Item Name: Replacement Skidtube (Fits LH or RH)

DRAWING NO. D2650	TITLE 206/407 SKIDTUBE ASSEMBLIES	REV. F	DART AEROSPACE LTD ENGINEERING ORDER		D.E.O. NO. D2650-F-1	SHEET NO. SHEET 1 OF 1	SCALE NTS
DRAWN	CHECKED	MFG. APPR.	APPROVED		DE APPR.		
DATE 12.10.12	DATE 12.10.22	DATE 12.10.22	DATE 12.10.22		DATE 12.10.22

PURPOSE:

CHANGE C'BORED WELDED CROSSBOLT SPACERS TO SWAGED SPACERS

DETAIL B

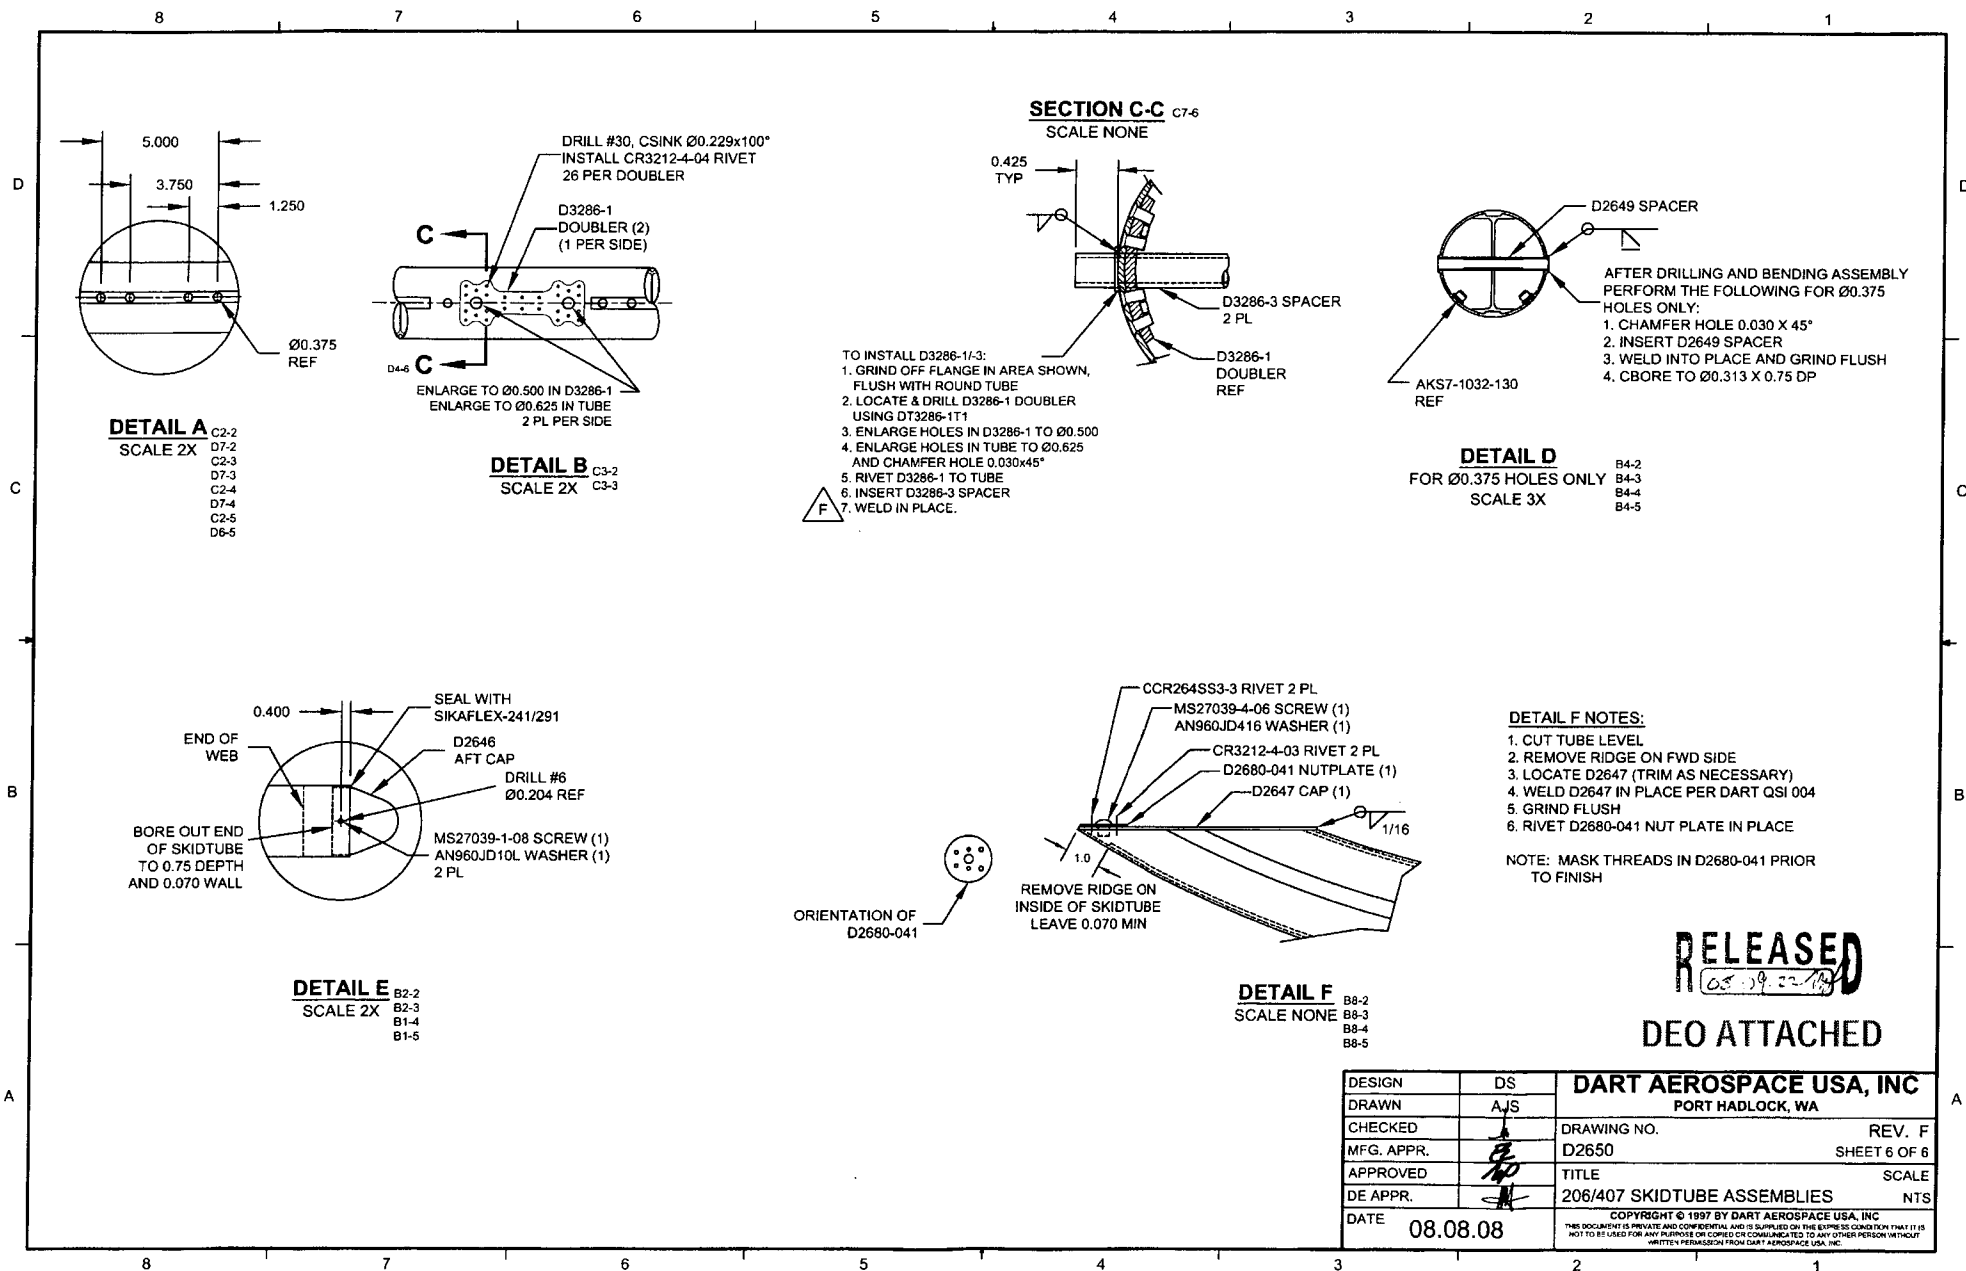
D2649 SPACER,
WELD PER DETAIL D OF DWG
BUT DO NOT C'BORE

AMENDMENT TO DETAIL B
NOT TO SCALE

DETAIL G

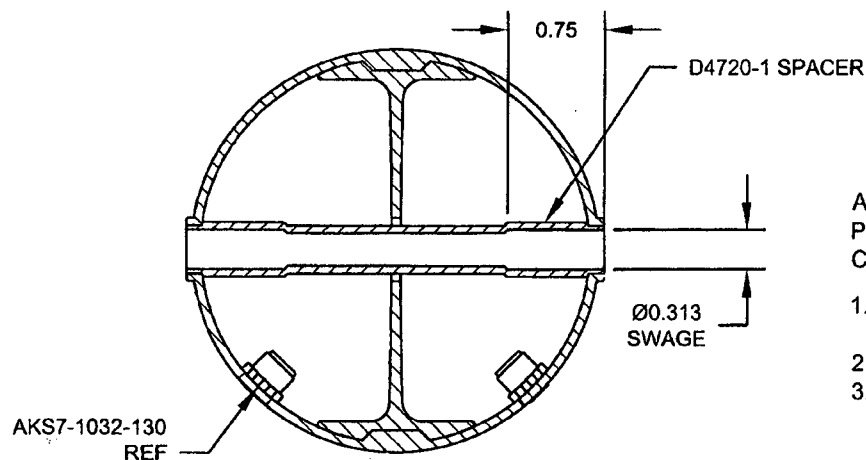
ADD DETAIL G BELOW, WHICH IS THE SAME SECTION VIEW AS DETAIL D OF DWG.

C'BORED HOLES ARE **NOW SWAGED** PER DETAIL G BELOW. FOR THE Ø0.375 HOLE THAT IS NOT C'BORED, WELD PER DETAIL D OF DWG (SEE AMENDED DETAIL B FOR REFERENCE).

FOR Ø0.375 HOLES ONLY

FOR HOLES THAT ARE CURRENTLY C'BORED ONLY
NOT TO SCALE

AFTER DRILLING AND BENDING ASSEMBLY
PERFORM THE FOLLOWING FOR Ø0.375 HOLES THAT ARE
CURRENTLY C'BORED:

1. INSERT D4720-1 SPACER, 16 PL (-1) OR 17 PL (-3)
OR 19 PL (-5) OR 23 PL (-7)
2. SWAGE TO Ø0.313 X 0.75 DP PER QSI 002
3. TRIM / GRIND FLUSH PER QSI 002
